5. Noise and Health Concerns

5.1 ETSU-R-97

5.2 Noise Monitoring by the Developer

Figure 23

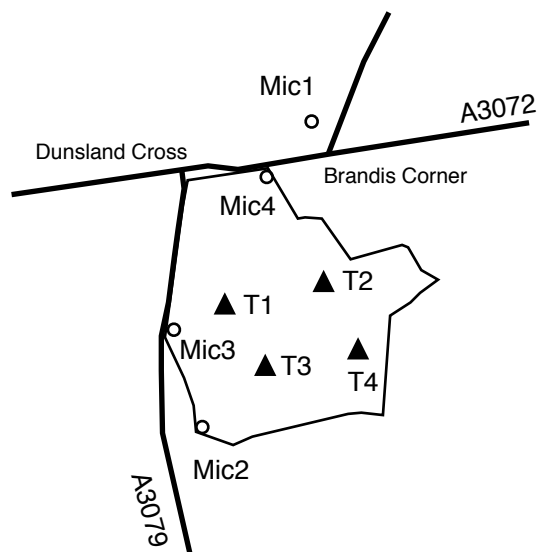
5.2.22 The locations described above are shown in Figure 23 below.

5.2.25 The proposal was not 'reasonable in the circumstances'. Firstly, the circumstances would not have arisen if many more residents had been contacted with a view to finding enough acceptable locations for microphones. It is yet another indication of the unwillingness of both Arcus and Bolsterstone to engage with the public (see Section 12: Public Consultation). Secondly, there were not enough microphones in suitable locations to enable the developer to assess and evaluate the derived noise limits at nearby properties in all **worst-case scenarios**. This is a noise monitoring requirement and in most cases will be as a result of **noise propagated downwind of the turbines**. Properties north-east of the turbines have not been catered for in this regard.

- Microphone 1 was sited in the populated cul-de-sac known as The Gardens near the centre of the village of Brandis Corner, close to the Public House which would be a source of noise in quiet daytime hours and some night time hours. It was placed near a constantly-running sewage-aeration pump. This pump is far enough away from the houses so as not to be noticeable, but close-up it is quite audible. DTOG questions why the developer chose to site microphone 1 near to this constant source of sound without declaring it, since the sources of noise at this location are listed as road noise, wind, trees and birds (crows) in Table 11.3 of the Environmental Statement.

- Microphone 2 was placed in a quiet field near the dwelling known as The Vale, over 100 metres away from any tarmac road. Sources of noise here are listed as road noise, trees, birds, sheep and dogs in Table 11.3. The dogs at The Vale are small puppies. Their occasional barking is not intrusive and would not register in any $L_{A90, 10min}$ measurement.

- Microphone 3 was in a field behind the hedgerow next to the A3079. It proved attractive to sheep grazing in the field. It was used as a rubbing post and in the week beginning 18th May the sheep had knocked it over. It was next seen righted again a few days later. Sources of noise at this location are listed as road noise, trees, birds and sheep in Table 11.3.

- Microphone 4 was sited next to the landowner's tractor shed, an area where farm machinery is often audible. Some residents reported increased levels of machinery noise during the monitoring period, particularly at night. Road noise, trees, birds, sheep and farm machinery are in the listing in Table 11.3.

- Although the monitoring period was from 8th - 27th May, **microphone 2 was taken out of service after its inspection on 19th May. No reason has been given for this.**

- Microphone 3, the sheep rubbing post seen to have been knocked over when viewed in the week beginning 18th May, was inspected on 19th May and was stood up again. No end date is given for the readings from this microphone. Perhaps it was damaged when it went over. **No acknowledgement of this incident is given in the Environmental Statement.**
